82nd GRSG
Informal Document No. 10

PROPOSAL FOR A REVISION TO REGULATION No. 107
(M2 and M3 vehicles)

Transmitted by the OICA

Note: The text reproduced below was prepared by the OICA in order to merge the requirements of Regulations 36, 52 and 107, together with European Community Directive 2001/85/EC.
WP29 has recommended that the new document should be based on Regulation 107.

Figure 1

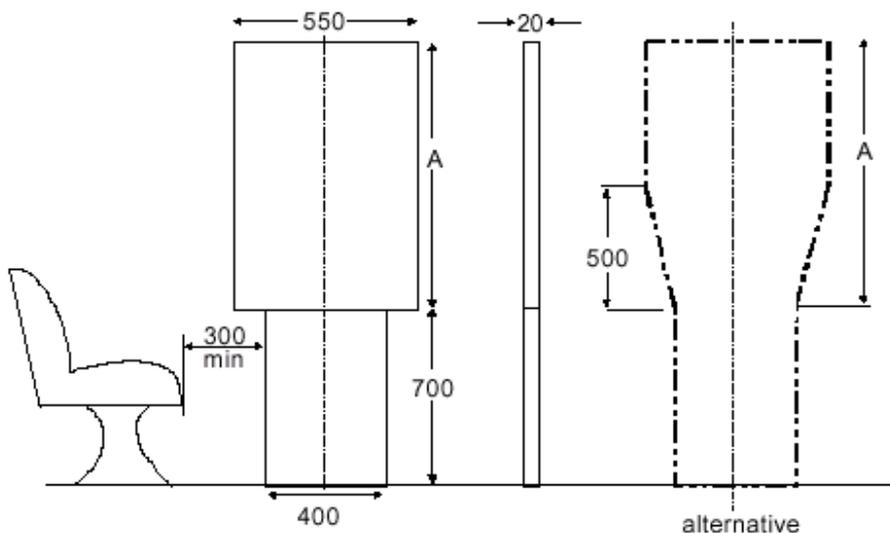
As shown above but with chamfer as ECE-52 and units in cm (shown in mm)

Figure 2

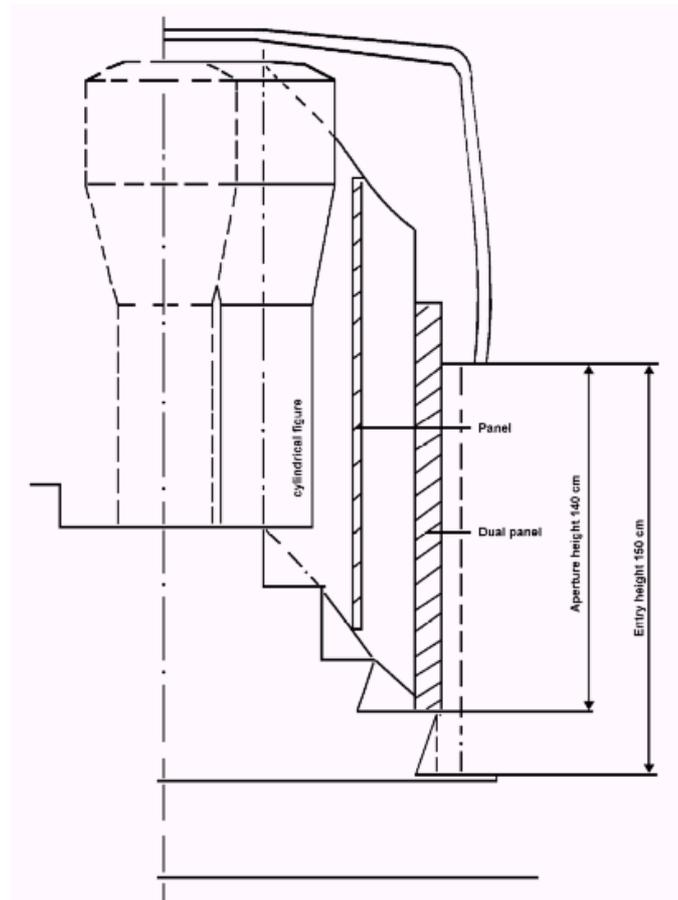
Note: Diagram should be clarified to identify the panels concerned by reference to their respective paragraphs/figures.

Figure 4

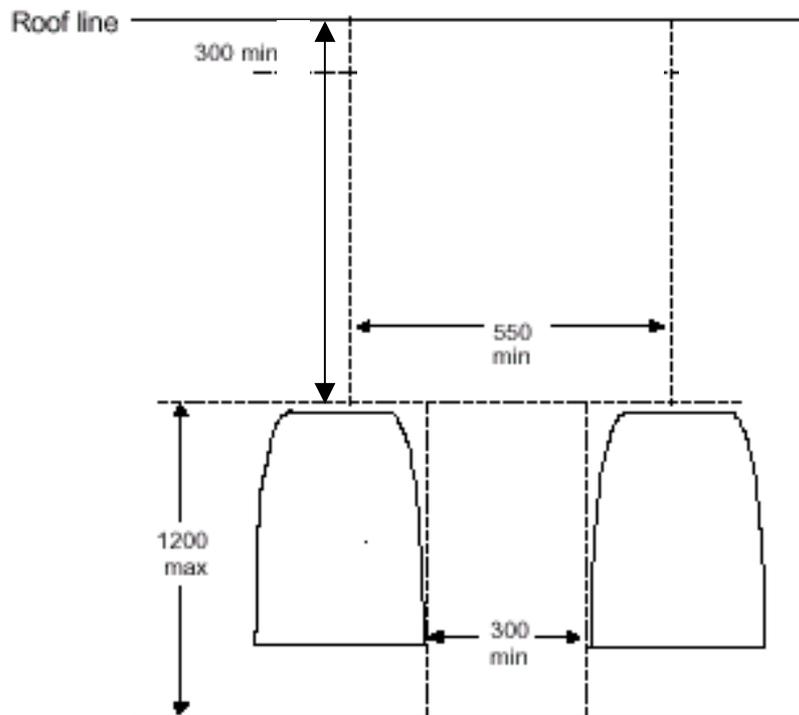
As shown above but with units in cm (shown in mm)

Figure 5

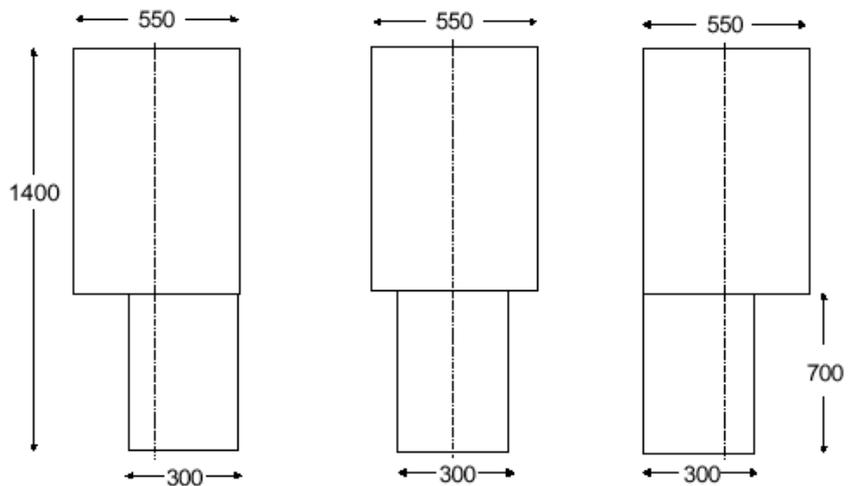
Diagrams should be redrawn to include chamfer at top, as provided for in paragraph 5.7.2.1 (see ECE-52), and with units in cm (shown in mm)

Figure 6**GANGWAYS**

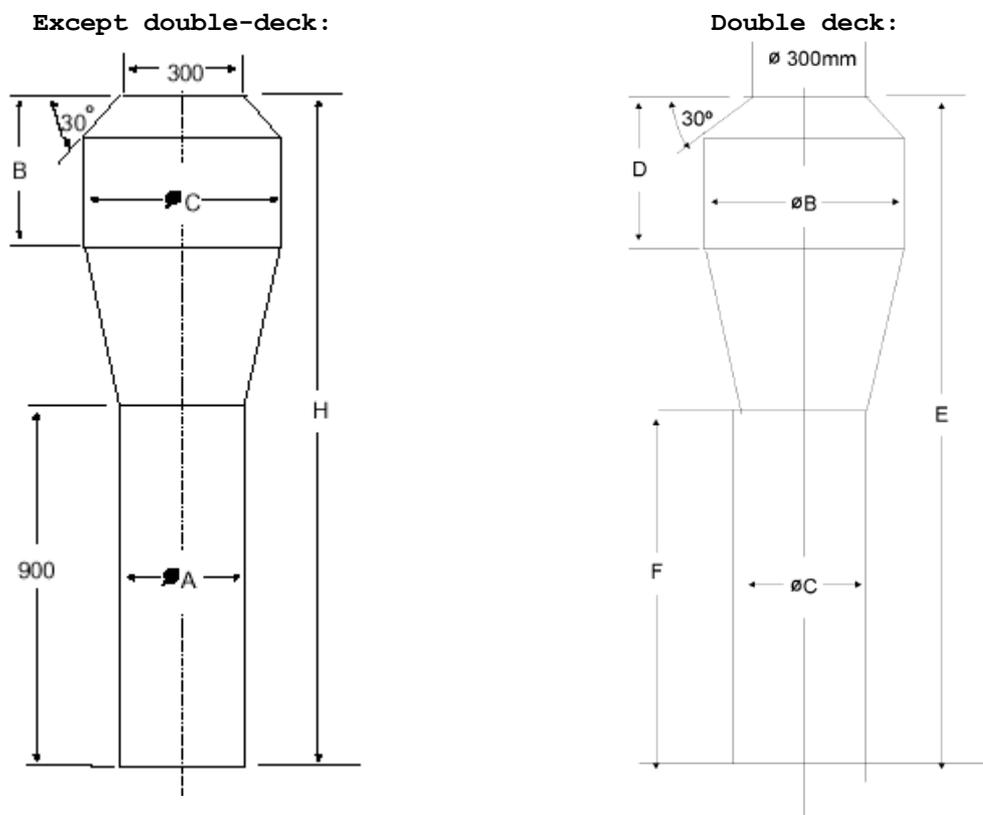
As shown above but with units in cm (shown in mm)

Figure 10

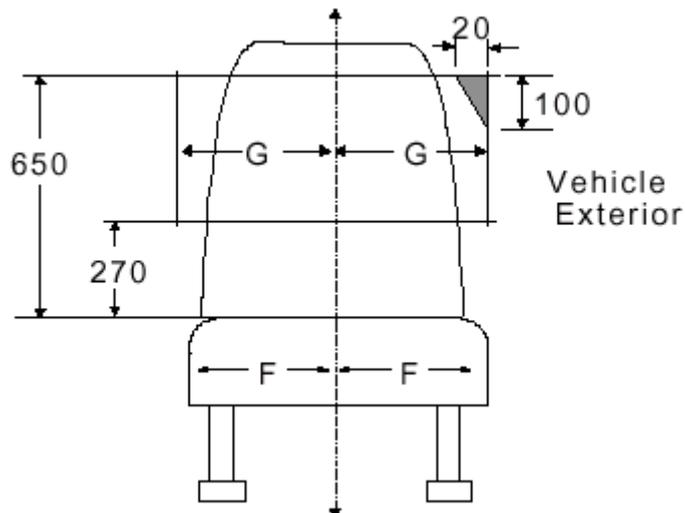
As shown above but with units in cm (shown in mm)

Figure 14

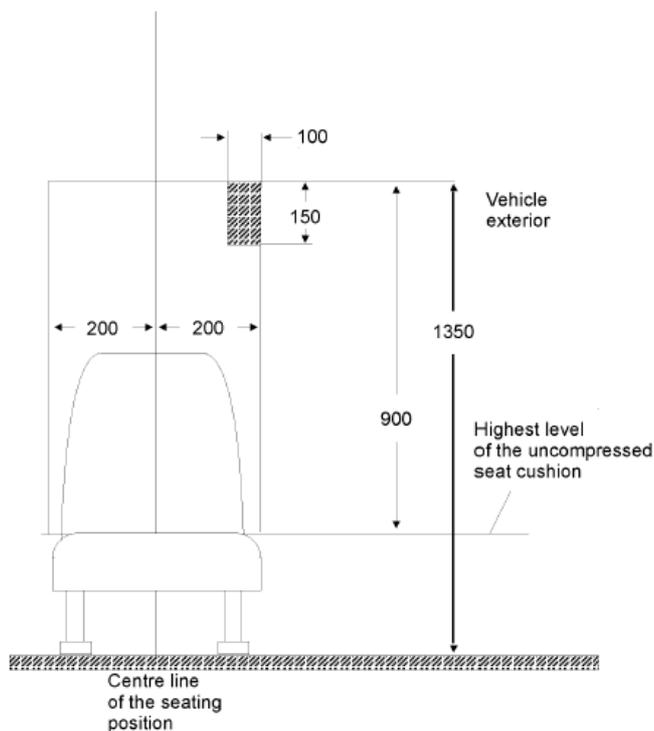
As shown above but with units in cm (shown in mm)

Figure 15

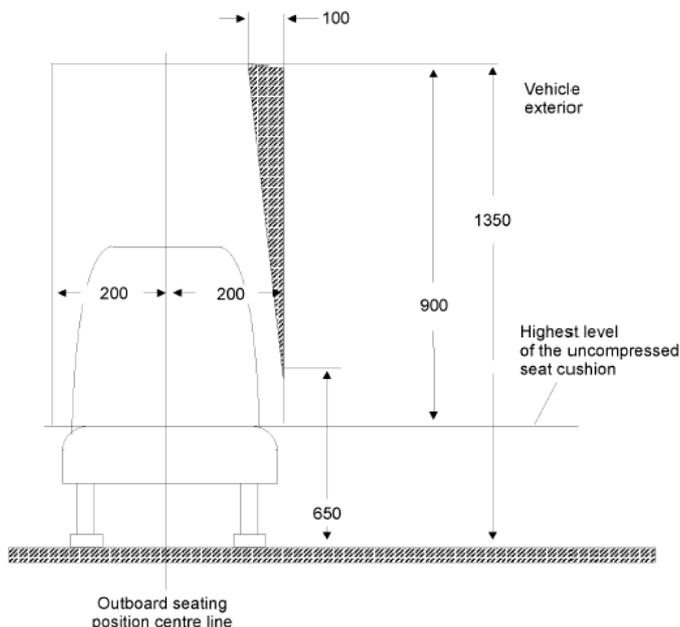
As shown above but with units in cm (shown in mm)

Figure 16

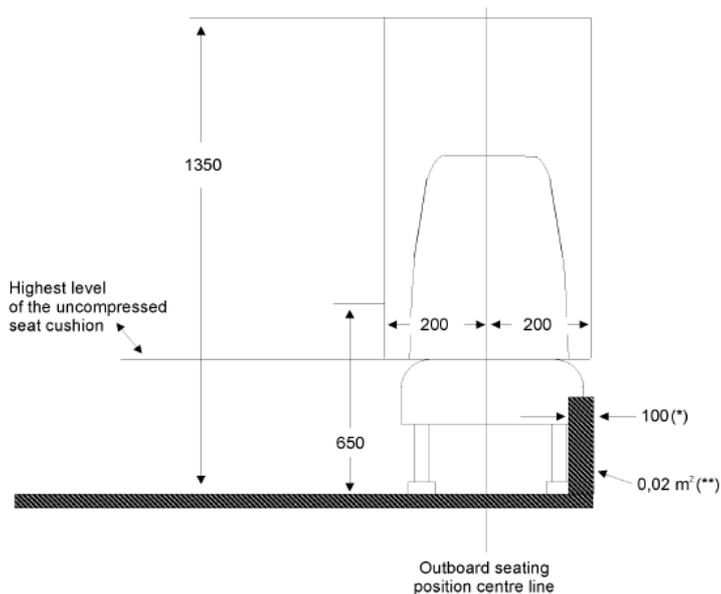
As shown above but with units in cm (shown in mm)

Figure 19

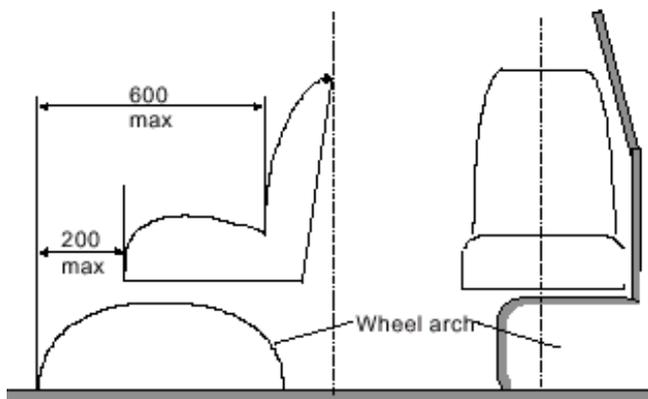
As shown above but with units in cm (shown in mm)

Figure 23

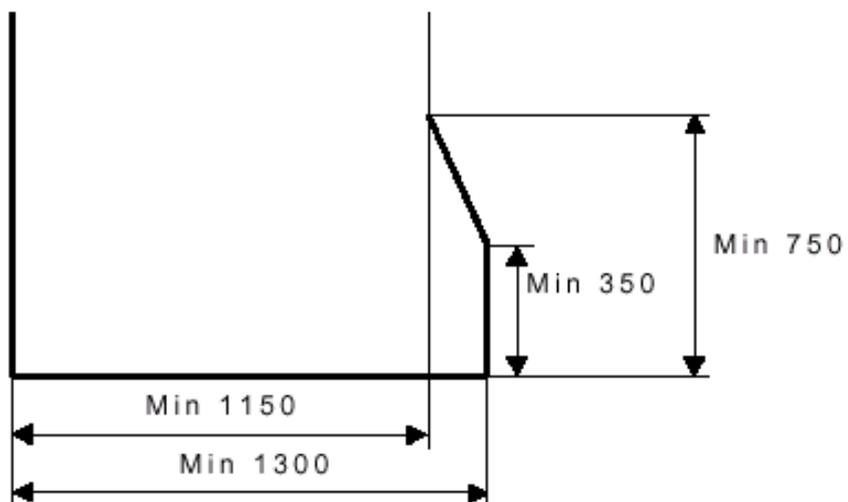
As shown above but with units in cm (shown in mm)
